FDA Executive Summary

Prepared for the
March 19, 2010 meeting of the
Circulatory System Devices Panel

P090013
REVO MRI SureScan Pacing System, Medtronic, Inc.

Figure 4: Atrial (left) and ventricular (right) PCT before and after repeat RF injection at approximately 131 mW dissipated power (near worst case clinically). No measurable change in PCT was noted after repeat exposures. Outlier data points are discussed in the text above.

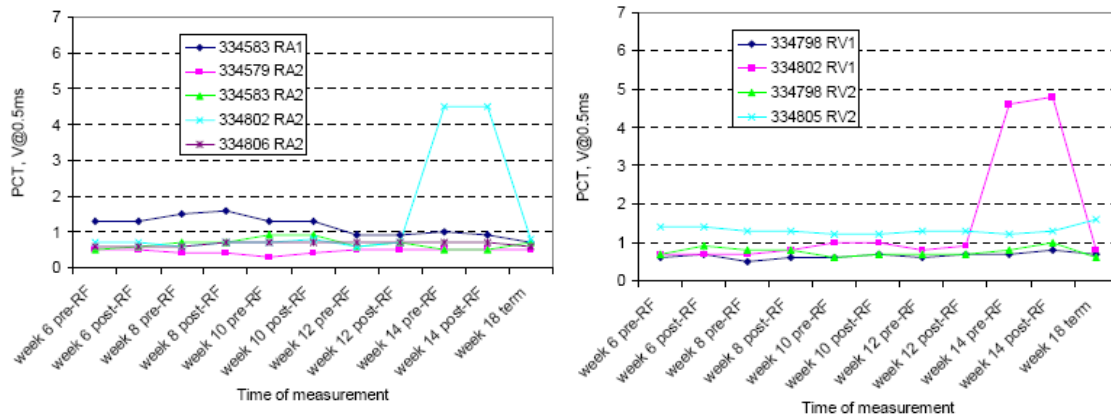
The second study discussed in this review (S2167) was intended to demonstrate that small changes in pacing threshold are not cumulative with multiple MRI exposures, a question that was not assessed in the clinical study. In this study, were each implanted with in the right ventricle and in the right atrium). After the leads matured, the animals were exposed to multiple direct RF injections at weeks 6, 8, 10, 12 and 14 post-implant. Some of the leads

were exposed to approximately 131 mW of dissipated power (near worst case clinically, according to the modeling data) while other leads were exposed to approximately 390 mW of dissipated power (well beyond worst case clinically, according to the modeling data). The lower energy data is shown in Figure 4 and the higher energy data in Figure 5. At 131 mW of dissipated power, no measurable change in PCT was noted after repeat exposures. At 390 mW of dissipated power, transient changes in PCT were seen but PCT recovered prior to the following RF injection with no cumulative effect noted. The sponsor notes that the outlier data seen in the week 14 assessments were all measured sequentially on the same day using the same equipment, indicating that equipment malfunction was the likely cause of the abnormality. FDA reviewed this animal study and concluded that it was well conducted. The Panel will be asked whether the data presented support the safety of multiple MRI scans for patients.
